INFORMATION SHEET FOR
PRELIMINARY OVERALL AREA DEVELOPMENT PLAN
(P.O.A.D.P.)

Ventura Springs Meadows

RE: Ventura POADP
File #86-21-60-26

Re: Ventura ☐ Preliminary Plan
☒ P.O.A.D.P.
File #: 84-21-60-26

P.O.A.D.P.

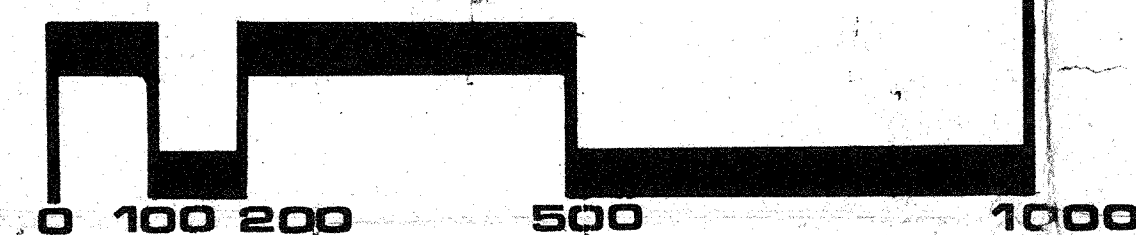
☒ lacks compliance with the Subdivision Regulations regarding:

| <input type="checkbox"/> Street jogs or intersections | <input checked="" type="checkbox"/> 36-10(M) (1) pavement and R.O.W. widths |
| <input checked="" type="checkbox"/> Cul-de-sac streets in excess of 500' | _____ |

☒ Comments: It will be necessary to upgrade street (Elm Trail) connecting Walzem Road and Crestway to a collectors standards.
